APPLICATION FOR URBAN DESIGN COMMISSION

UDC RESUBMISSION

618 S. Park Street Project: Regarding: Façade Improvement

PREVIOUSLY APPROVED OPTION: 10/17/2012 UDC MEETING

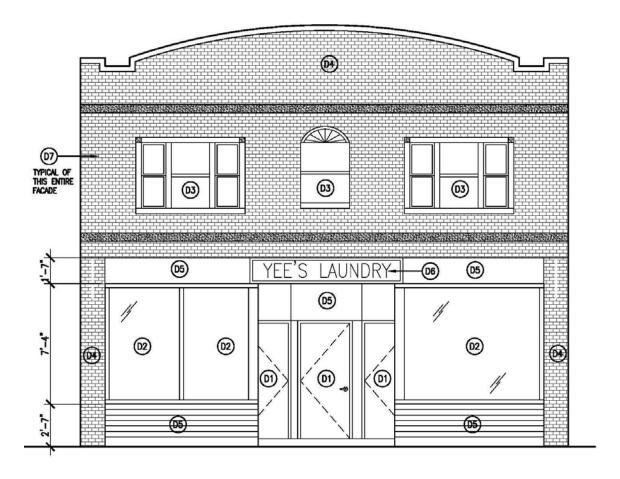
Recognizing that there was an initial approval, and a later amendment, I believe that this rendering demonstrates a design that would be acceptable as it only varies slightly in appearance from the originally submitted design. Changes include: sign board above windows in lieu of transom glass; MDO or similar composite material in lieu of metal panels; slight color change.

The recent unapproved material change from the approved metal panel to split faced block was not a deliberate intent to ignore the UDC approved design, rather, Ms. Jiang was unaware of the consequences of changing the design in the field. However, we hope to remedy this construction effort, and any resulting frustrations that this may have caused.

NEWLY PROPOSED OPTION: 2/13/2013
